MANDATORY SERVICE BULLETIN

MSB 42-148

MSB 42NG-094

Replacement of the main landing gear (MLG) and nose landing gear (NLG) retaining rings.

1	Pull and tag the GEAR circuit breaker to prevent inadvertent landing gear operation.
2	<p>Locate the retaining rings. See Figure 1 for MLG locations and Figure 2 for NLG locations.</p>  <p style="text-align: center;">Figure 1: MLG Retaining Rings</p>

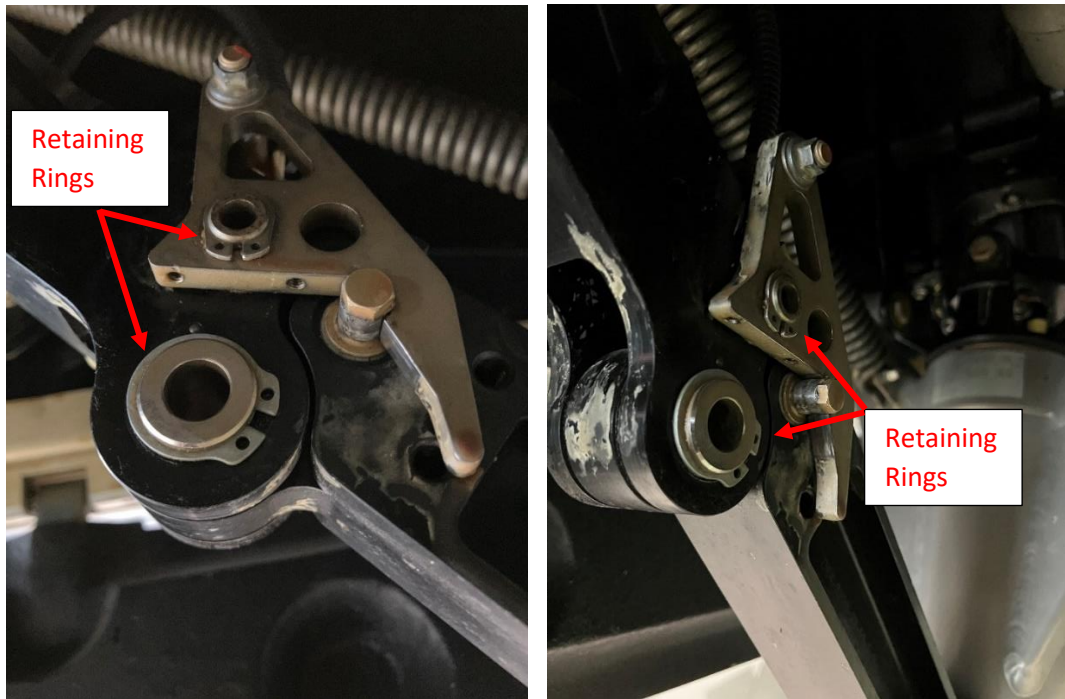
It was discovered that the main and nose landing gear braces of some aircraft had retaining rings with insufficient level of corrosion resistance being installed. This may cause the retaining rings to corrode, sustain damage, or fail (crack). If not corrected, this may lead to failure of the landing gear. This Service Bulletin describes the replacement of those retaining rings.

3	Replace one retaining ring at a time.
4	Remove the retaining rings from the MLG legs and NLG leg as per the figures. (Refer to Figures 1 and 2 for location)
5	<p>CAUTION: Do not remove or move shafts while replacing retaining rings:</p> <p>Clean the grooves of the bearing shafts. Inspect the folding stay and bearing shafts for general condition before installing the new retaining rings.</p> <p>NOTE: If for any reason the folding stay, and/or the bearing shaft needs to be removed for repair / replacement / further inspection, perform work in accordance with AMM section 32-00, then proceed to step 6.</p>
6	<p>NOTE: Do not overstretch the retaining rings during installation. Open the rings only enough to fit over the shaft when installing.</p> <p>Install the new retaining rings. Make sure the retaining rings properly engage into the grooves of the bearing shafts.</p>
7	Clean working areas, check for foreign objects.

Quantity	Part Number	Description
4	DIN471-10-MZP	DIN 471-10x1.0-MZP, Retaining ring (MLG Brace Assy LH and RH)
4	DIN471-20-MZP	DIN 471-20x1.2-MZP, Retaining ring (MLG Brace Assy LH and RH)
2	DIN471-18-MZP	DIN 471-18x1.2-MZP, Retaining ring (NLG Brace Assy)
2	DIN471-10-MZP	DIN 471-10x1.0-MZP, Retaining ring (NLG Brace Assy)
